P&Z STAFF REPORT

Board of Appeals Hearing; November 10, 2016

Case: **V16-0121 – 4644 E Conway Dr**

REQUEST

SITE PLAN (FULL SITE PLAN AS ATTACHMENT)

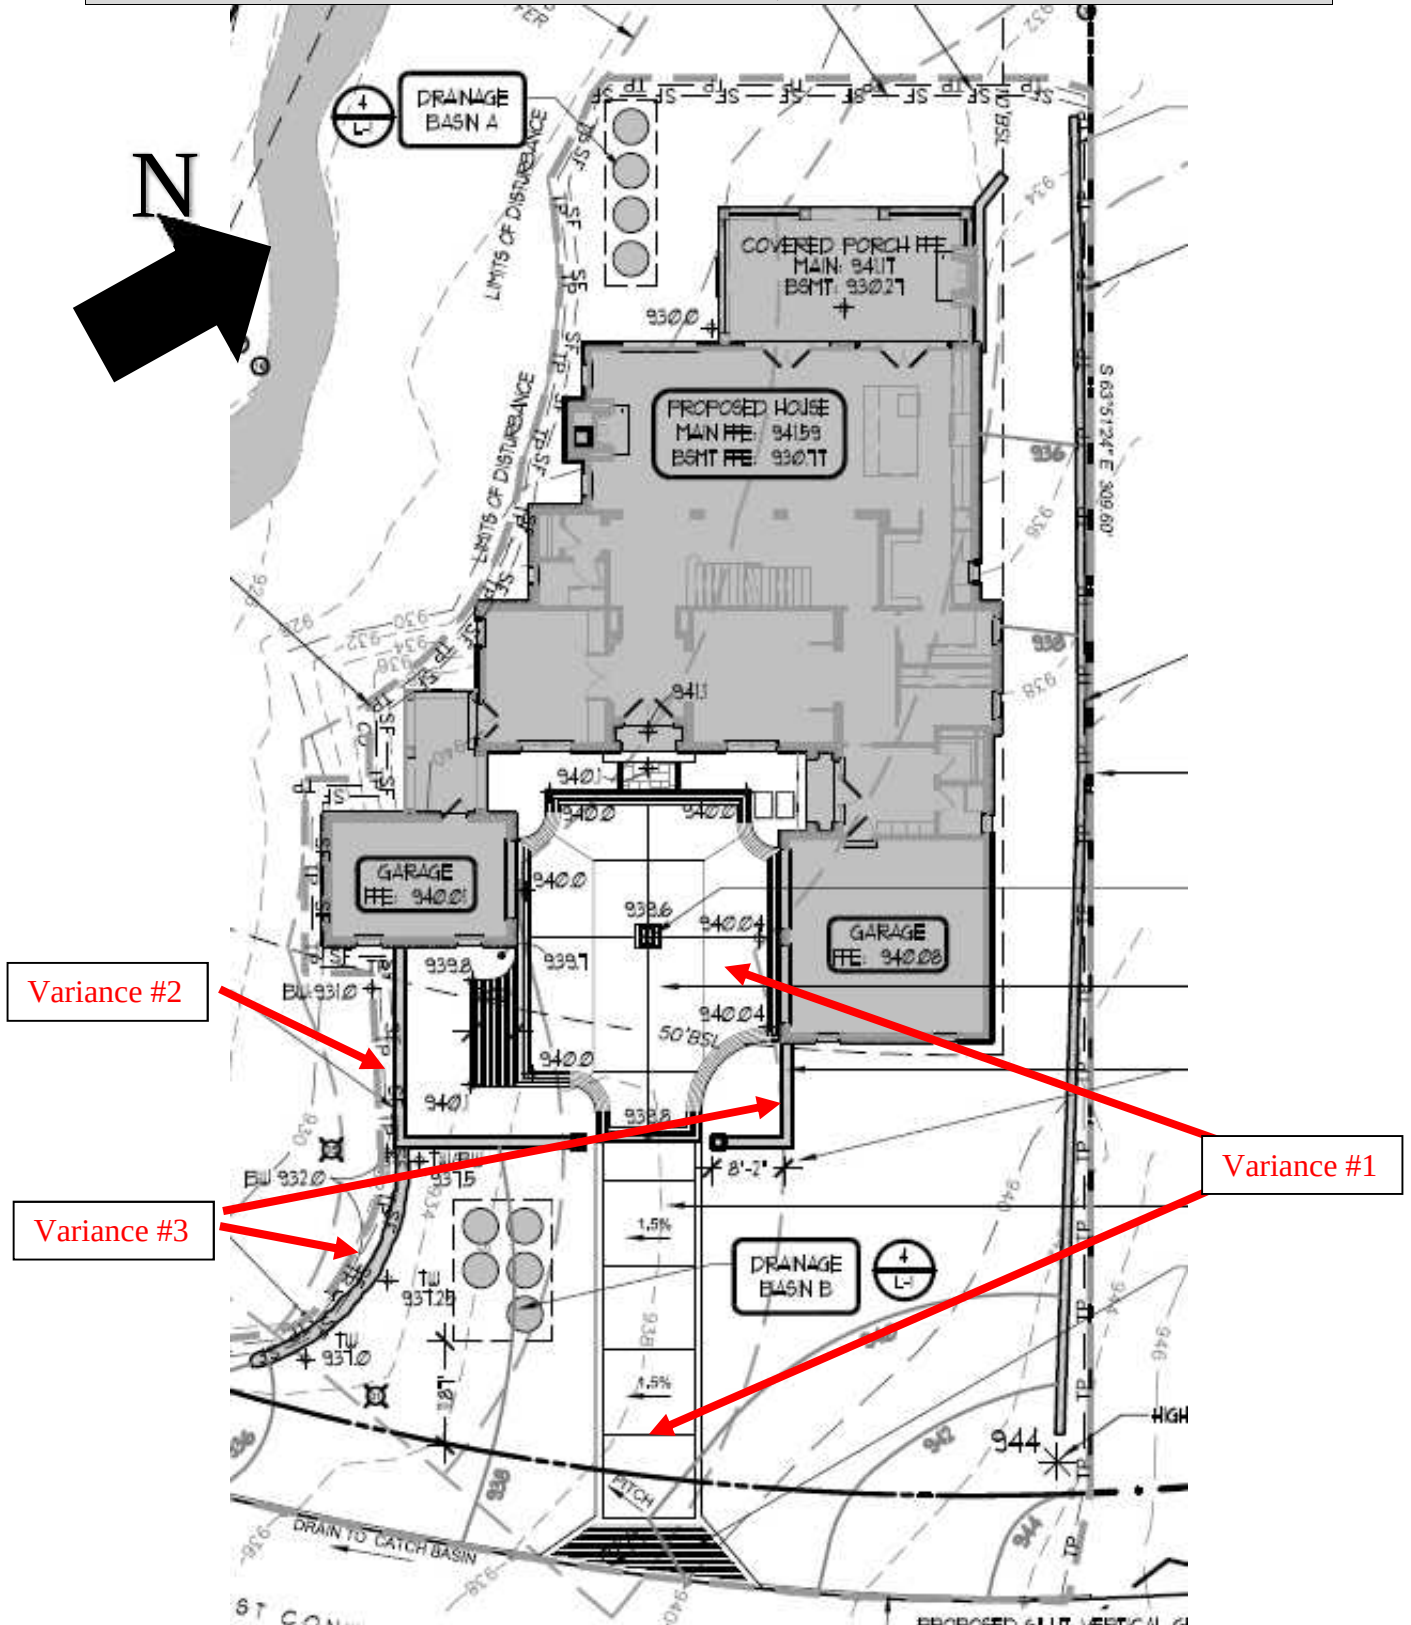
The applicant is currently constructing a single-family residence. The parcel at 4644 E Conway Dr is split by a stream, leaving the property undevelopable without a stream buffer variance. In 2013, the applicant applied for a variance to allow for construction in the 50-foot City stream buffer and the 25-foot City impervious surface setback. In its December 10, 2013 hearing, the Board of Appeals approved the variance request subject to conditions.

Since 2013, the City granted a residential building permit based on the 2013 variance approval, and construction started on the residence. As part of a random site inspection, a City Land Development Inspector found encroachments into the 25-foot State stream buffer, failure to maintain construction best management practices such as silt fences, and construction of a retaining wall without a permit. The Inspector issued a stop-work order on September 9th, 2016. Since then, the applicant has provided a planting plan for the encroachments into the 25-foot buffer that was recently approved by Staff. To this date, the stop-work order is still in place until the Board of Appeals considers Variance request #2 and the applicant receives a retaining wall permit.

In addition, and beyond the 2013 request, the applicant proposes to install an additional boulder retaining wall and a free-standing wall in the front yard, and to replace the previously proposed pervious driveway with concrete.

The encroachments into the different regulated areas are as follows for the proposed project, the 2013 variance request, and the previous residence that occupied the site prior to 2013.

Buffer	Previous residence (sf)	2013 Variance case (sf)	Proposed Plan (sf)	Difference Proposed-2013 (sf)	Difference proposed 2013
25-foot State	366	0	0	0	-
50-foot City	2,005	1,442	1,780	338	+ 23.4%
25-foot City Setback	1,471	1,680	3,133	1,453	+ 86.5%
Total	3,842	3,122	4,913	1,791	+ 57.4%

Approval of variance request #1. **Denial** of variance requests #2 and #3.

SHEET NO. L-1
NORTH
GRADING & DRAINAGE EXHIBIT

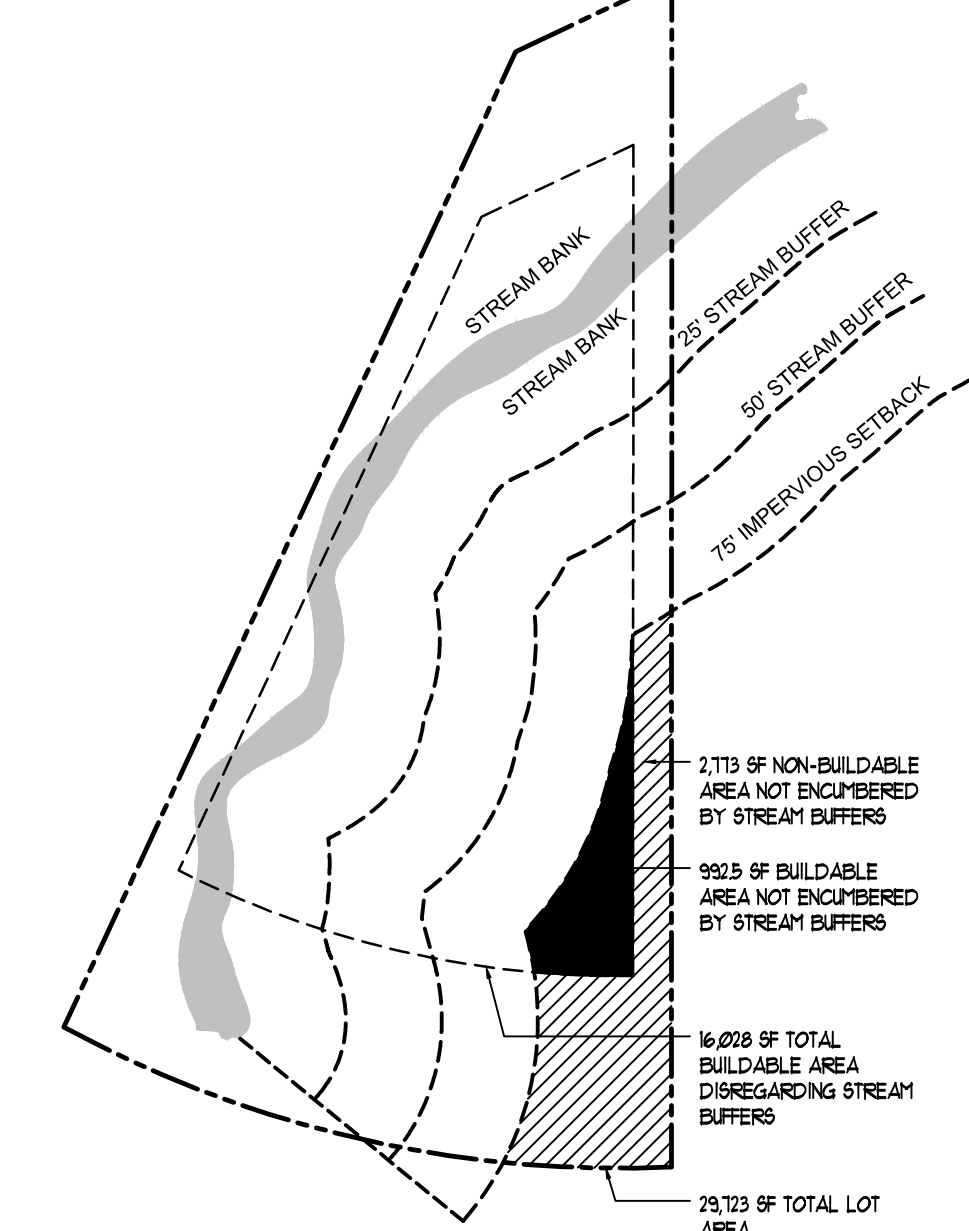
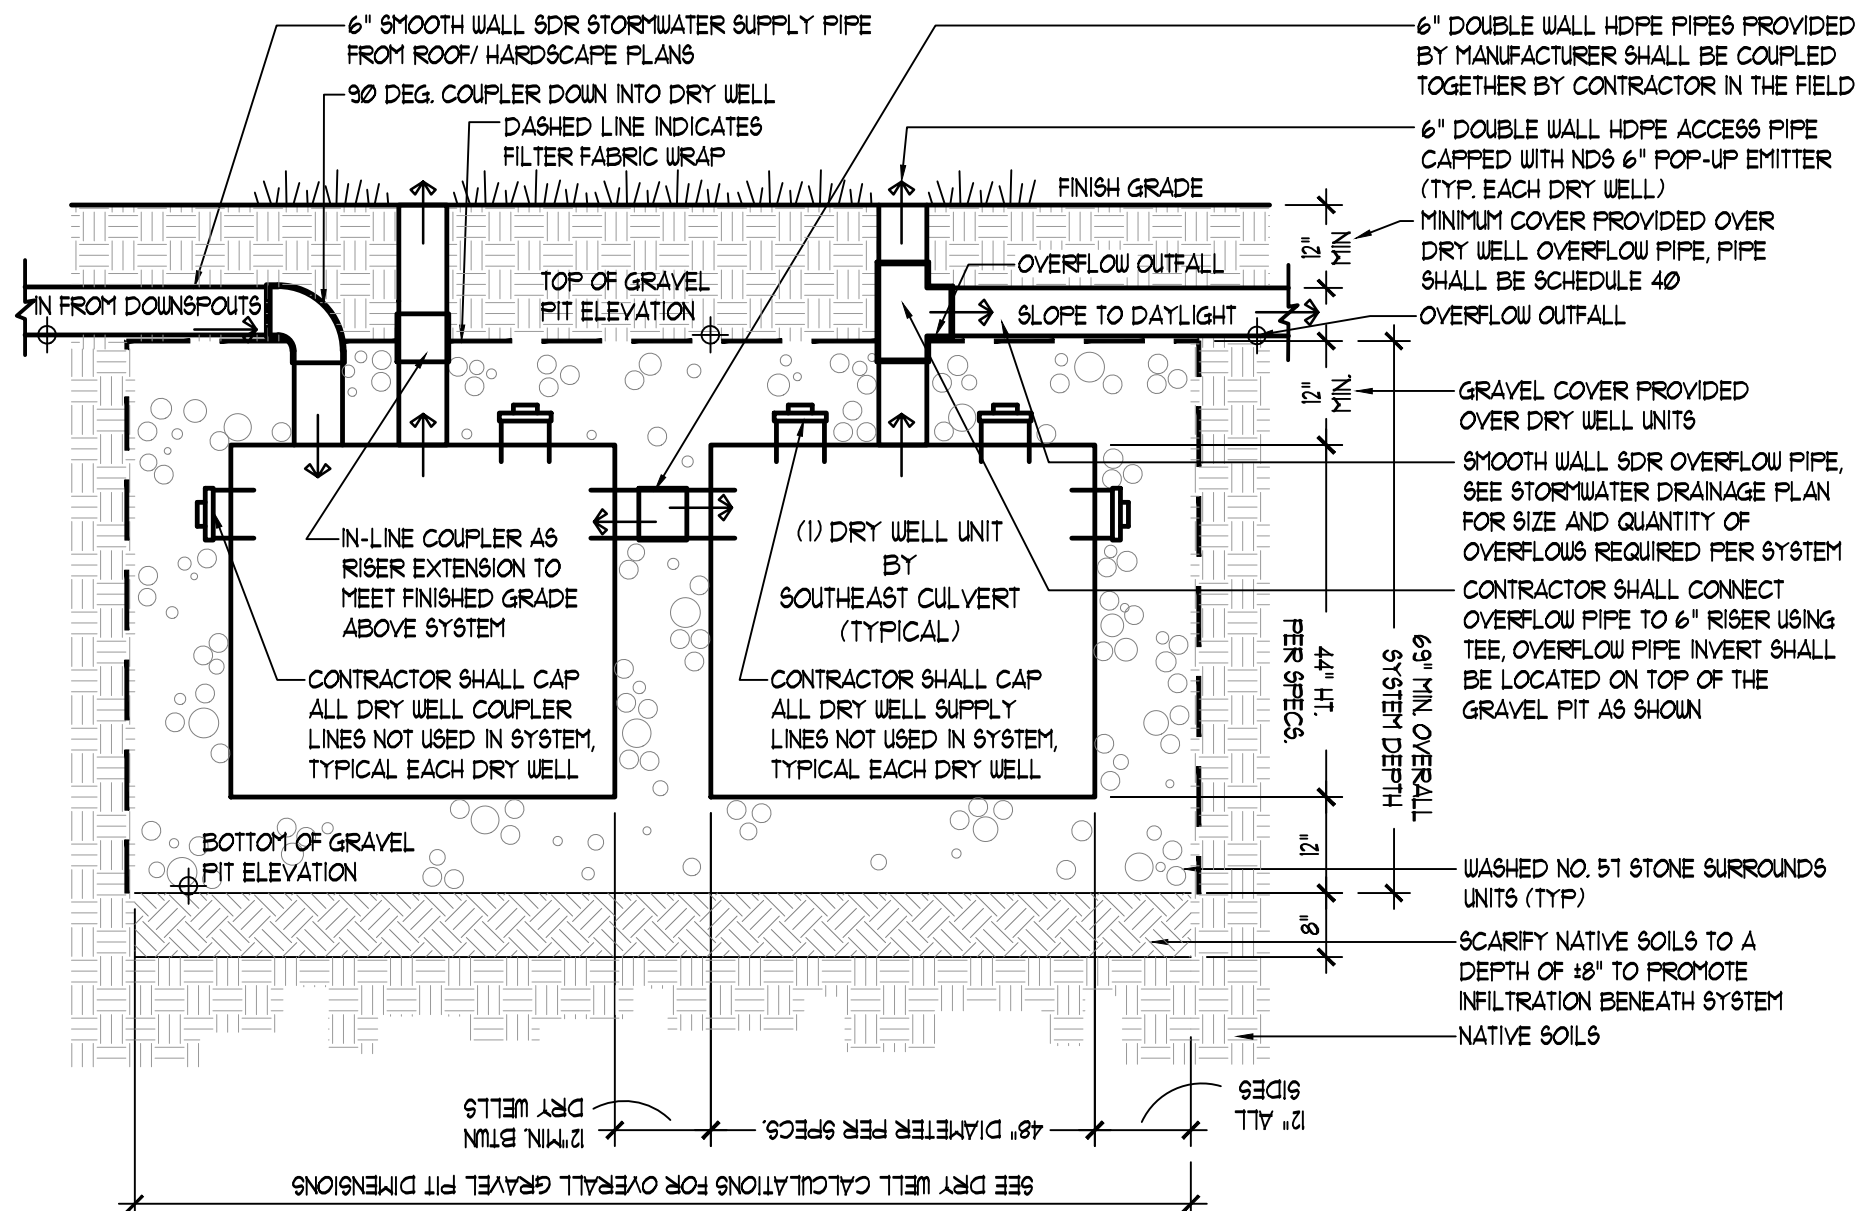
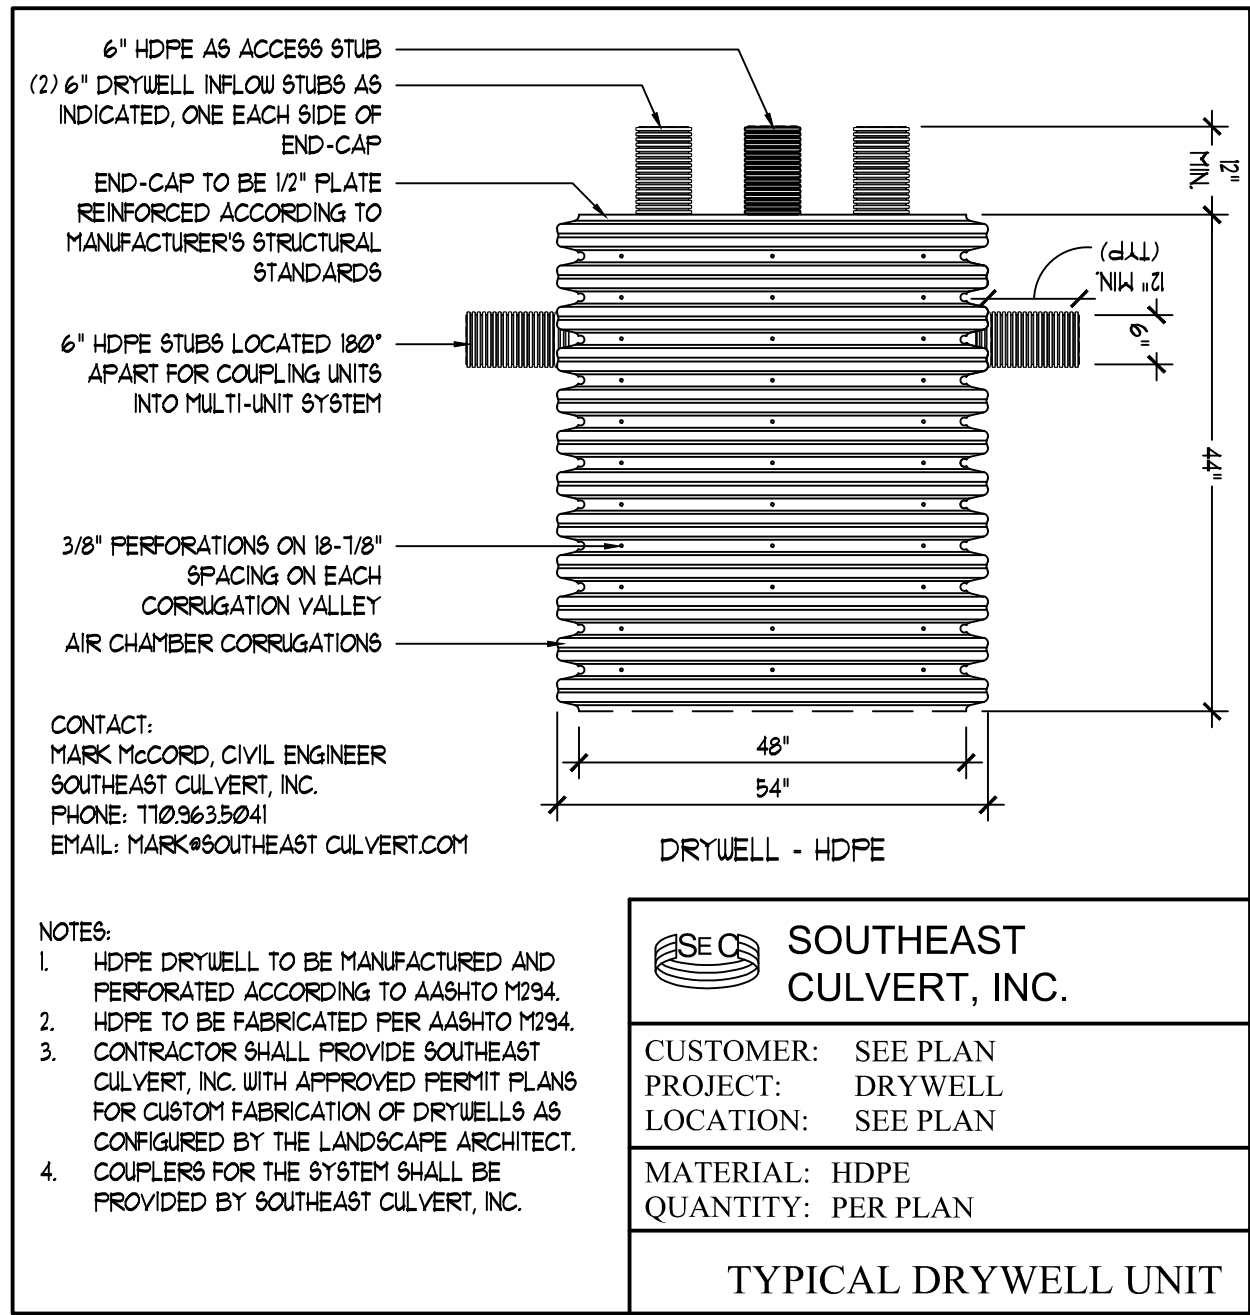
- a. Our plan proposes to mitigate the proposed impervious surface driveway by directing the storm water runoff into an infiltration system of dry wells located on the low side of the driveway leg that approaches the residence from the street. We have engineered this dry well system to accommodate 130% of the required 1.2" rainfall per city ordinance. It is important to note that the dry well systems handling infiltration for ALL impervious surfaces on the site are proposed to be upgraded to handle 130% of the required storm water volume per city ordinance. This extra 30% of infiltration volume goes above and beyond city requirements and is intended to help mitigate runoff from entering the stream system during the typical rain event. Please refer to sheet L-2 for storm water mitigation plans and calculations.

Our proposal reduces the total size of the approved drive by 395 sf to 1,575 sf. We propose to swap the surface to impervious concrete and cobblestones. We will infiltrate all runoff from the driveway in a dry well system located outside the motor court area on the low side of the driveway approach leg from the street. The total volume of storm water storage will equate to 130% of the standard 1.2” of rainfall per city ordinance. See sheet L-2 for calculations.
